RE: P.Z. 14-2013 St. Luke's Hospital-West Campus (175 S. Woods Mill Rd.): A request for a zoning map amendment from "MU" Medical Use District, "R-2" Residence District and "FPNU" Flood Plain Non-Urban District to create a new "MU" Medical Use District for a 40.3 acre tract of land located west of the intersection of South Woods Mill Road and Hwy 141 (18Q140343, 18Q510278, 18Q230204 and 18Q210211).

Planning Commission Vote Report

RE: P.Z. 14-2013 ST. LUKE'S HOSPITAL – WEST CAMPUS

PRELIMINARY PLAN FOR "MEDICAL USE" ZONING AMENDMENT PARCEL "B" PARCEL "D"

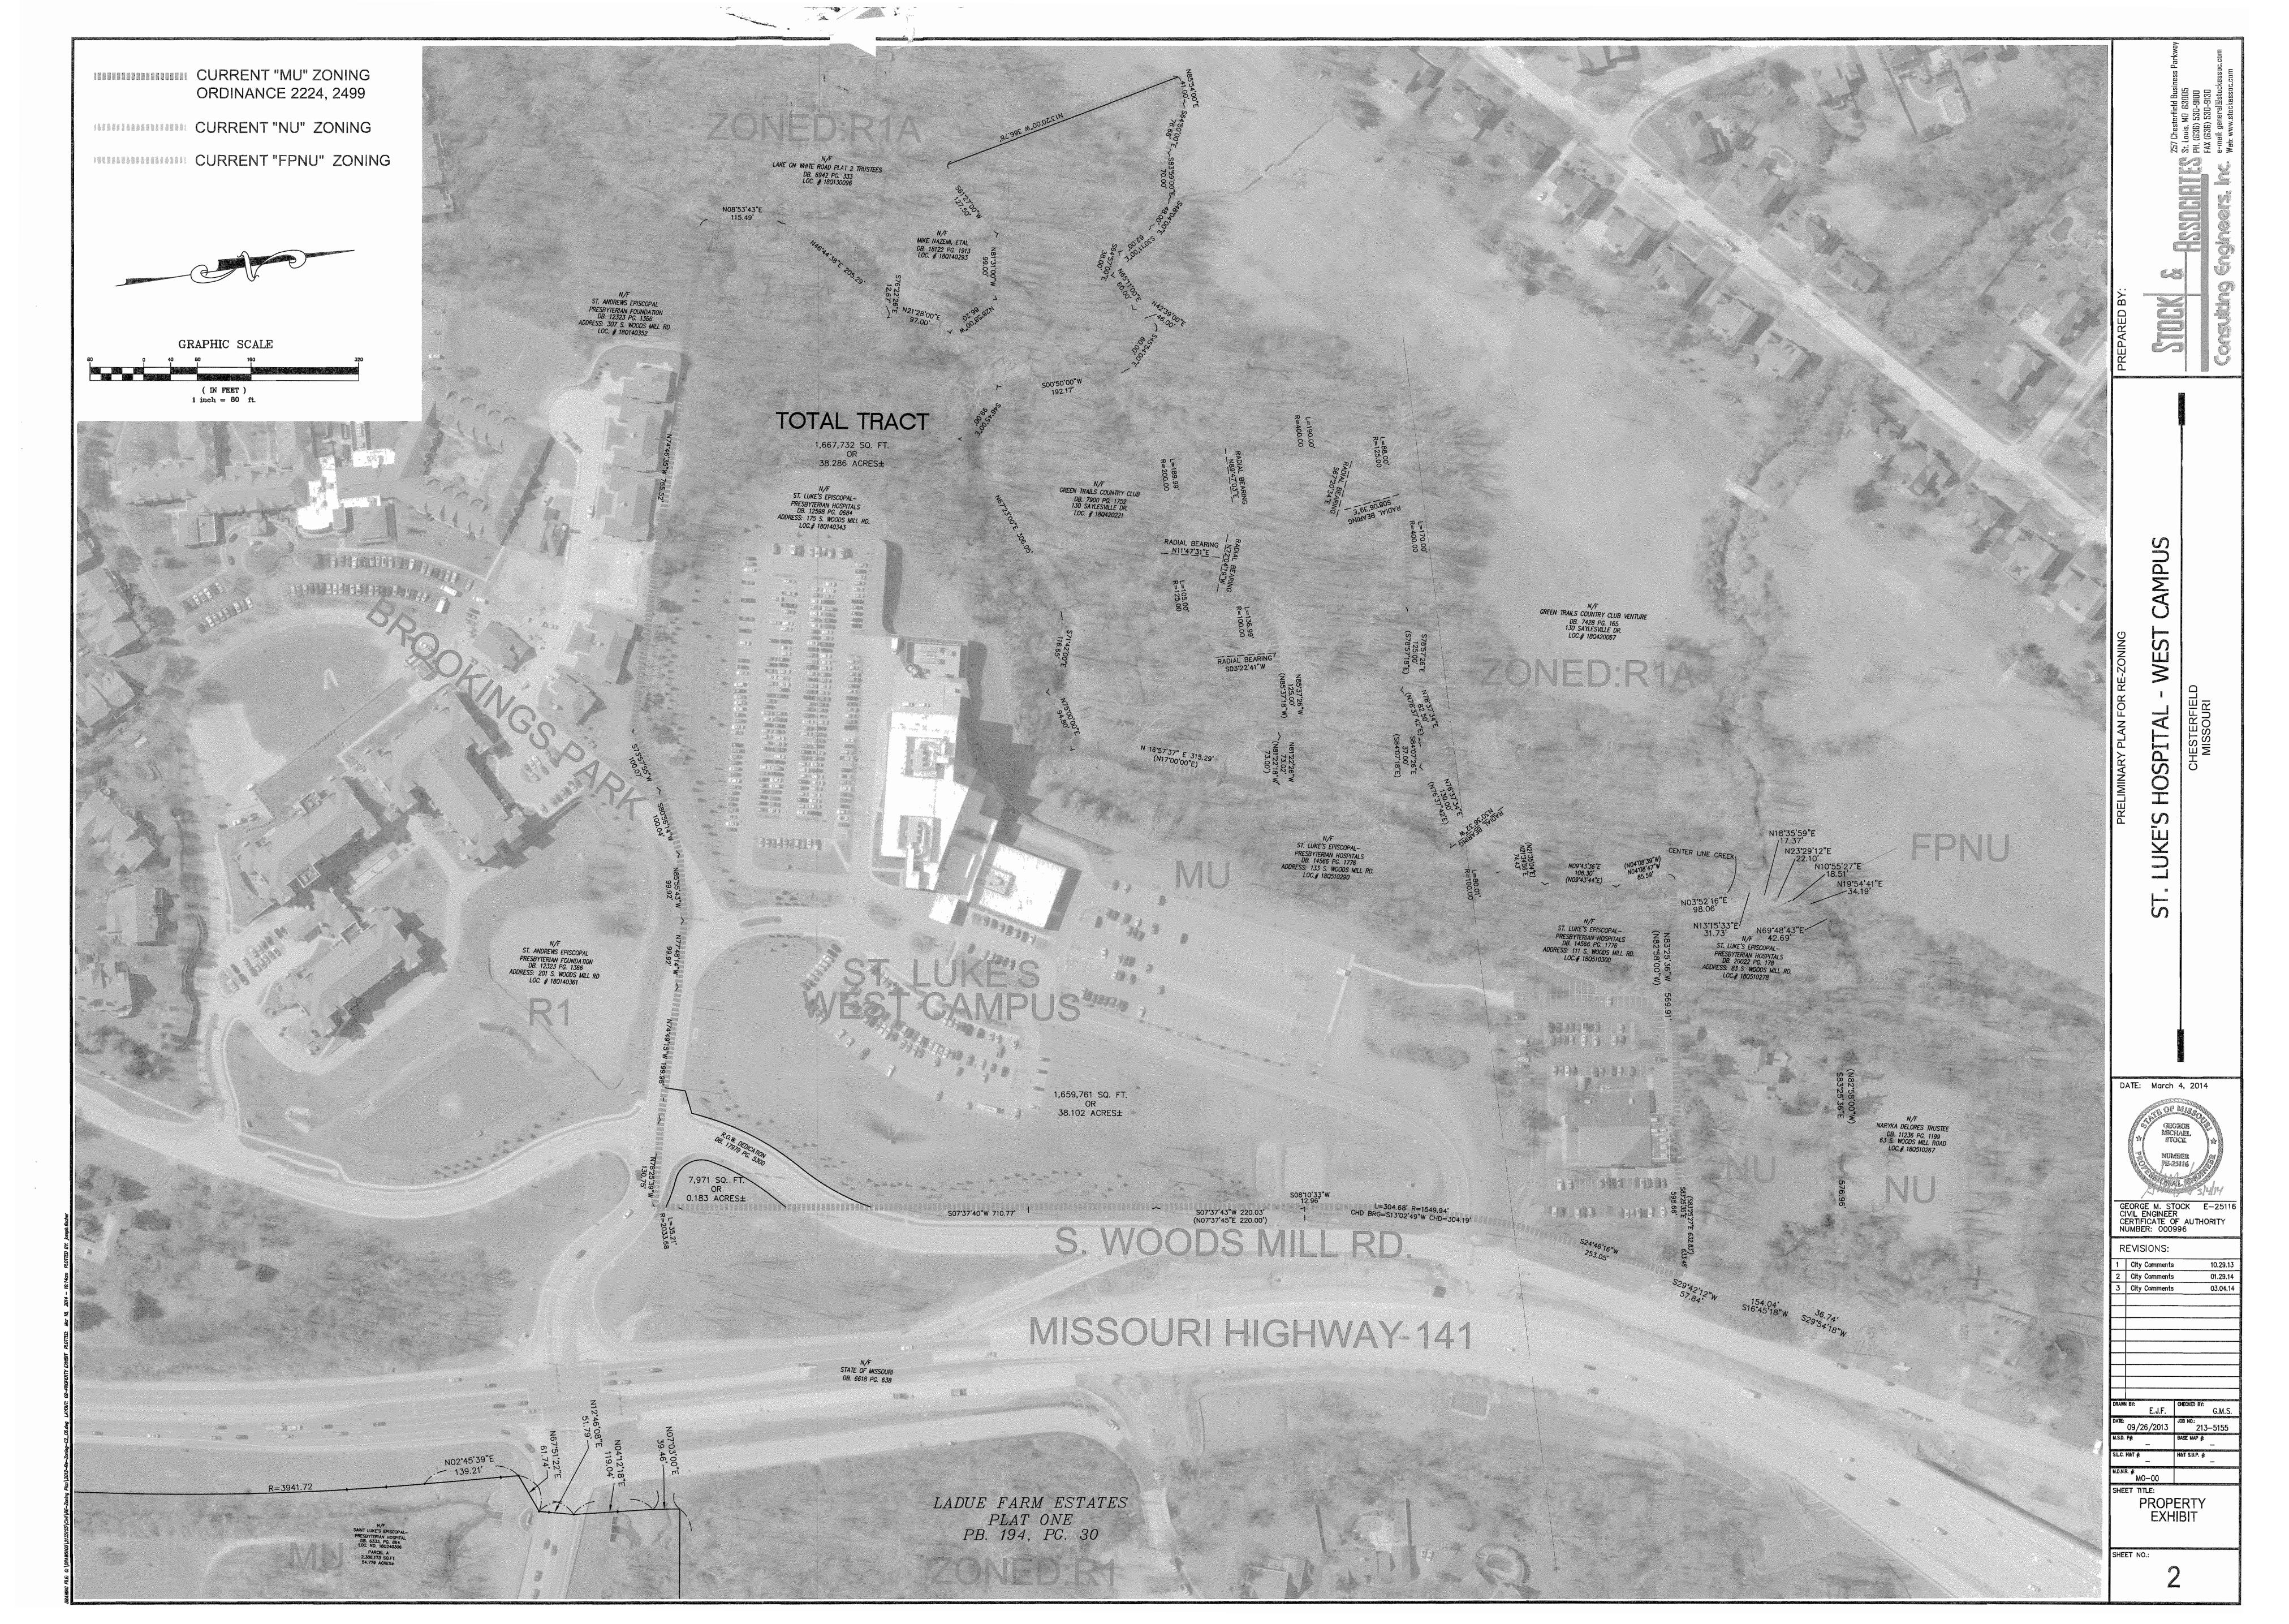
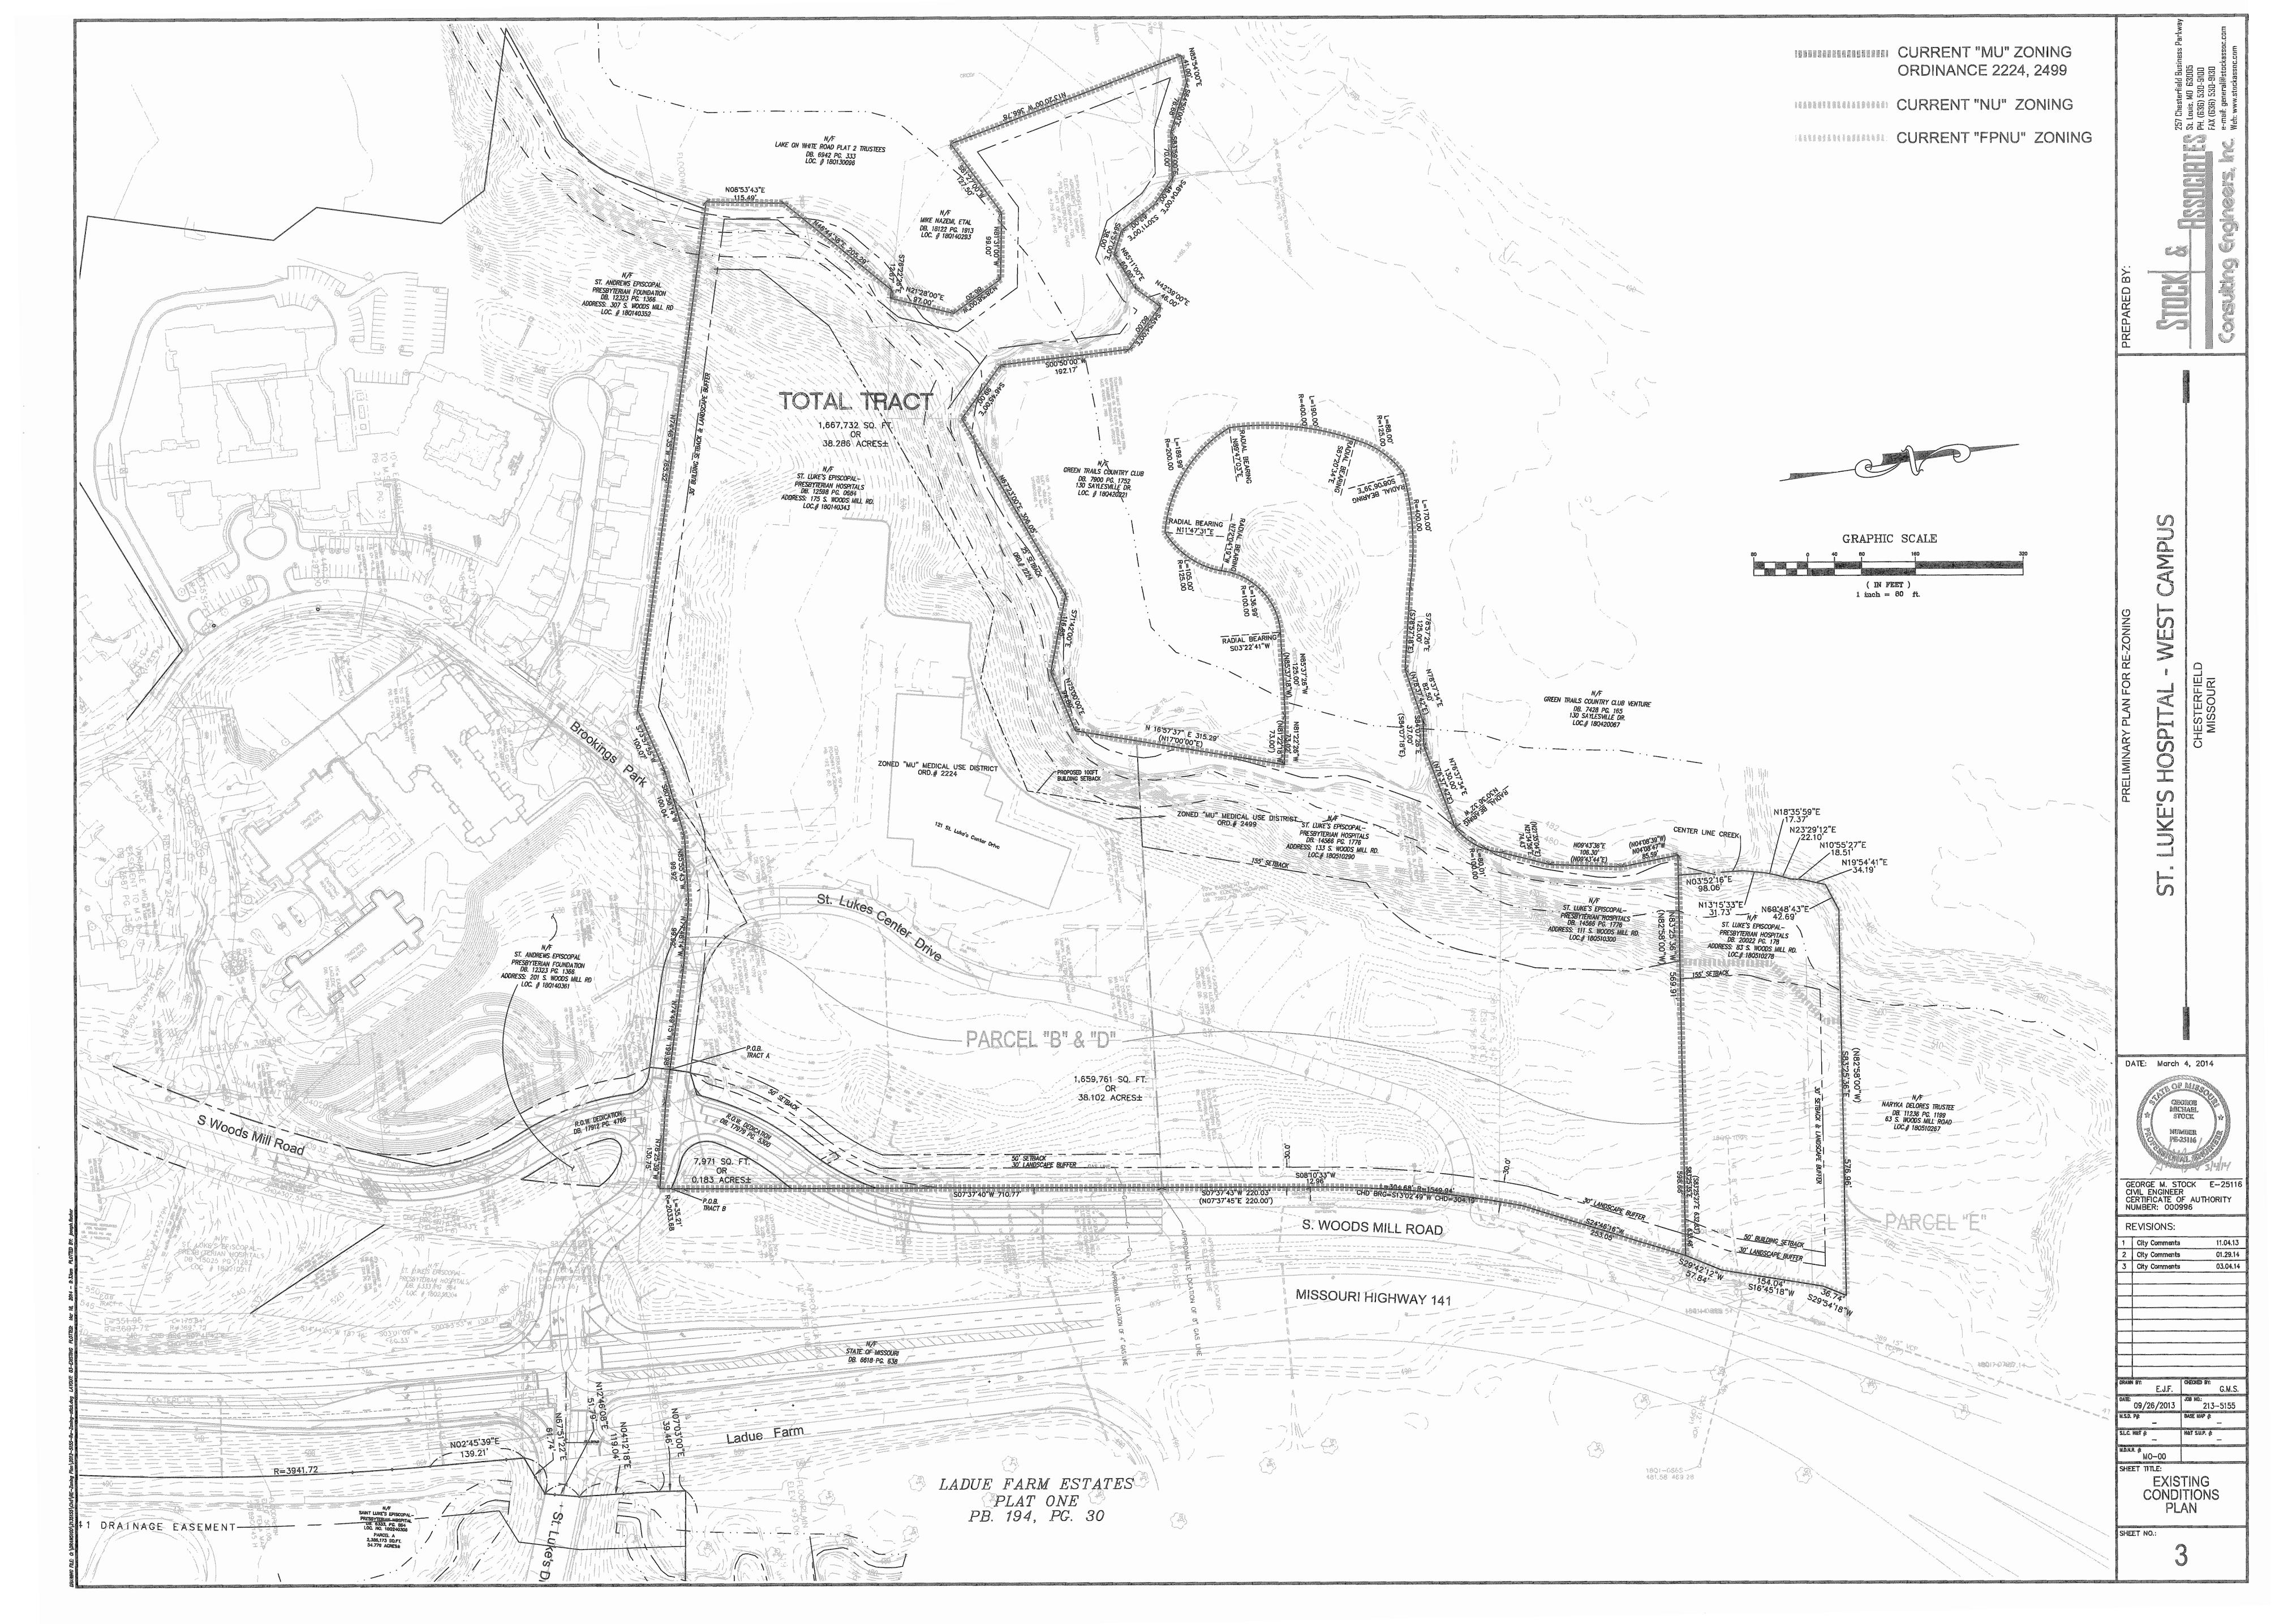
- 2. Correction of setbacks and landscape buffers on the Preliminary Plan as follows:
 - Depict the required 30 foot landscape buffer along the southern border of Parcel B.
 - While the previous ordinance permitted a 25 foot setback along the southern border of Parcel B, evaluate a 30 foot building setback to accommodate the 30 foot landscape buffer.
 - Identify the 30 foot landscape buffer along the east and north boundary of Parcel E.
 - The 25 foot building setback should be increased to accommodate this 30 foot landscape buffer on Parcel E. Amend the north setback to be 30 foot.
 - The east setback for Parcel E is 50 foot.

The Revised Plan shows the correct setbacks and landscape buffers.
